Project	IEEE 802.16 Broadband Wireless Access Working Group < http://ieee802.org/16 >	
Title	MS Identity Privacy in 802.16m	
Date Submitted	2009-1-6	
Source(s)	Haihong Zheng, Shashikant Maheshwari, Yousuf Saifullah	Haihong.Zheng@nsn.com
	NSN Jan Suumaki	jan.suumaki@nokia.com
	Nokia GeneBeck Hahn, KiSeon Ryu and Ronny YongHo Kim	gbhahn@lge.com , ksryu@lge.com , and ronnykim@lge.com
	LG Electronic Inc.	
Re:	TGm SDD: 10.6.2.1 AMS Privacy	
Abstract	Propose temporary station identifier to support MS identity privacy	
Purpose	For discussion and adoption in 802.16m SDD	
Notice	<i>This document does not represent the agreed views of the IEEE 802.16 Working Group or any of its subgroups. It represents only the views of the participants listed in the "Source(s)" field above. It is offered as a basis for discussion. It is not binding on the contributor(s), who reserve(s) the right to add, amend or withdraw material contained herein.</i>

MS Identity Privacy in 802.16m

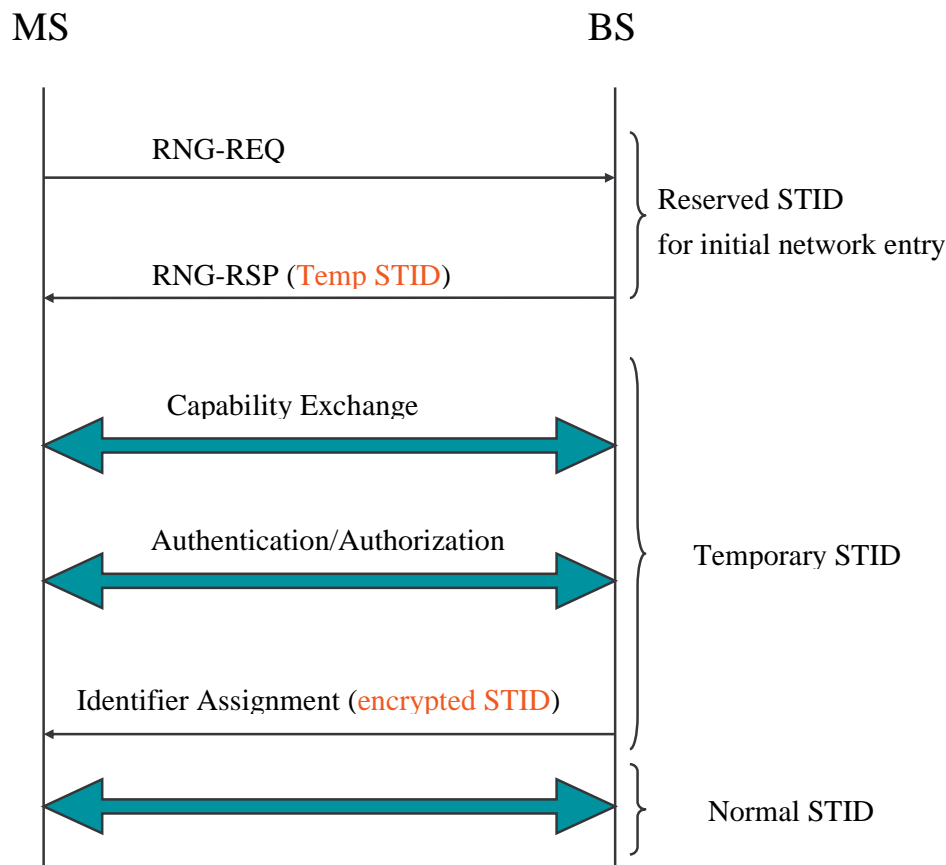
In order to solve the problem above, a Temporary Station Identifier (STID) is assigned during initial ranging process. After being assigned, it is used for the subsequent network entry procedures until the normal STID is allocated. Normal STID is assigned during/after authentication process, and the assignment message shall be encrypted. The temporary STID is then released and normal STID is used for all the remaining transactions. The detailed procedure is illustrated in the following figure.

In order to protect the mapping between the STID and the AMS MAC Address, two types of station identifiers are assigned to an AMS during network entry - temporary STID (TSTID) and (normal) STID. A TSTID is assigned during initial ranging process, and is used until the STID is allocated. The STID is assigned during the authentication process, and the assignment message is encrypted. The TSTID is released after STID is assigned. The STID is used for all the remaining transactions.
